MODEL

G01 (X3)	G30 (5 Series)	G12 (7 Series)
----------	----------------	----------------

INFORMATION

The replacement in-tank fuel pump has an extra port and fuel line attached on the underside of the fuel pump/tank flange.

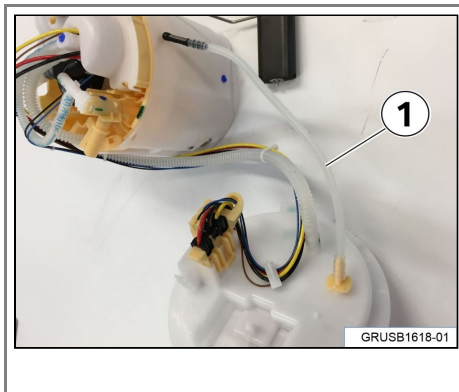
The replacement part is designed as a universal part for all Markets. The US market **does not** utilize the extra fuel line (1) that applies to the stationary or parked car heating – Option code SA 536A.

Modify the universal replacement fuel pump assembly to allow it to be correctly installed in a US market vehicle.

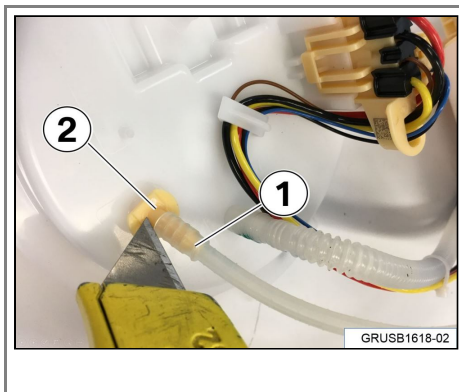
Carefully cut the parked car heating line (1) from the underside of the fuel pump mounting flange (2) (this section of fuel line is no longer needed).

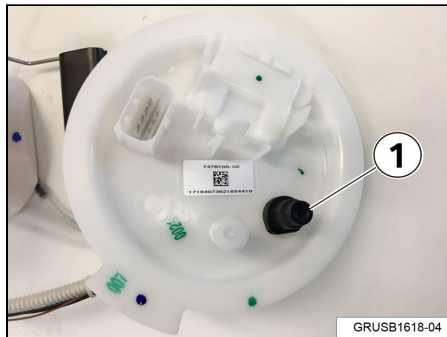
Remove the red cap from the auxiliary port (1).

Install the locking cap (PN 16 11 7 462 535) on to the open auxiliary port (1).
